SUBJECT: Forwards responses to GE Svc. Info Ltr 402 re wetwell/Drywell inerting. Operating instructions for containment inerting sys & primary containment sys revised.

ENCLOSURE
IMPLEMENTATION OF GENERAL ELECTRIC
SERVICE INFORMATION LETTER 402
"WETWELL/DRYWELL INERTING"
BROWNS FERRY NUCLEAR PLANT

FIGURE 1

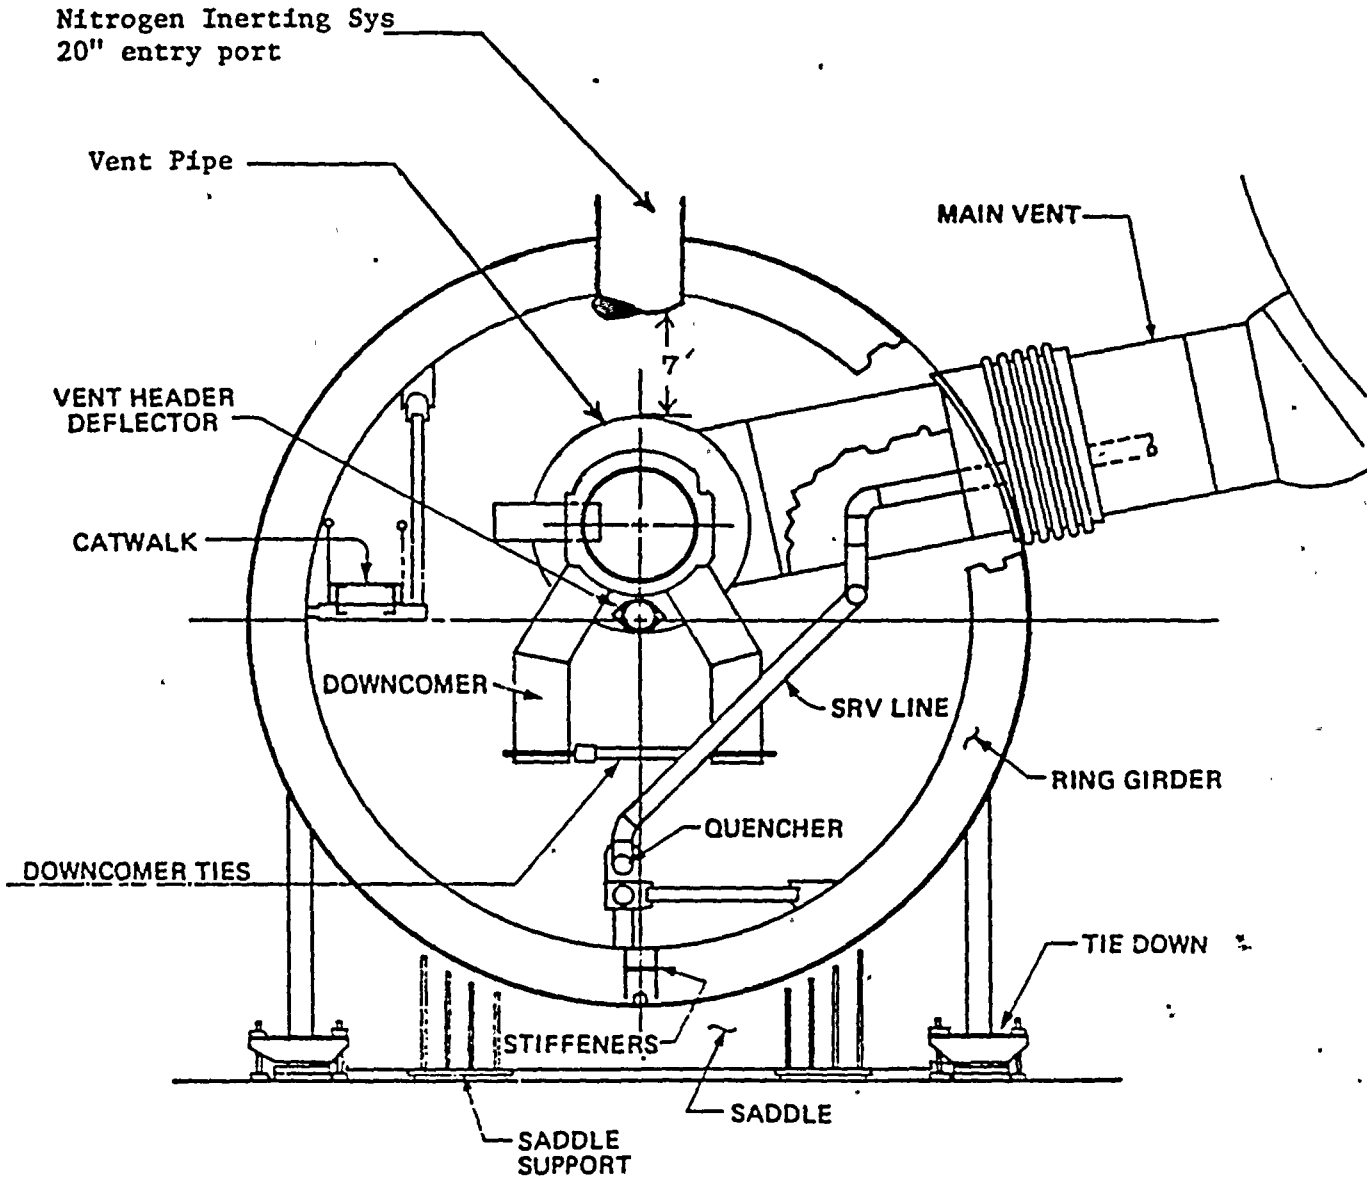
Indicate the location of your
Nitrogen Inerting System entry Port.

We have reviewed the system design of the Browns Ferry containment inerting system. The current system design has multiple controls and indications which are sufficient to prevent cold nitrogen (<50°F) from flowing into the primary containment. During purging operations, nitrogen flow and temperature is monitored in the control room to maintain >50°F nitrogen temperature. If nitrogen temperature decreases to <50°F, the low temperature shutoff valve will close and prevent injecting cold nitrogen into the primary containment. During makeup operations, the makeup vaporizer electric heater will energize if nitrogen temperature decreases to <70°F and the low temperature shutoff valve will close if nitrogen temperature decreases to <50°F. The continued use of these low temperature setpoints will preclude any low temperature problems. It should be noted that the configuration of the nitrogen injection piping into the wetwell at Browns Ferry is different from the configuration at Hatch Nuclear Plant as shown in figures 1 and 2. As such, the liquid nitrogen and/or cold gases would not impinge directly on any downcomer or the vent header.
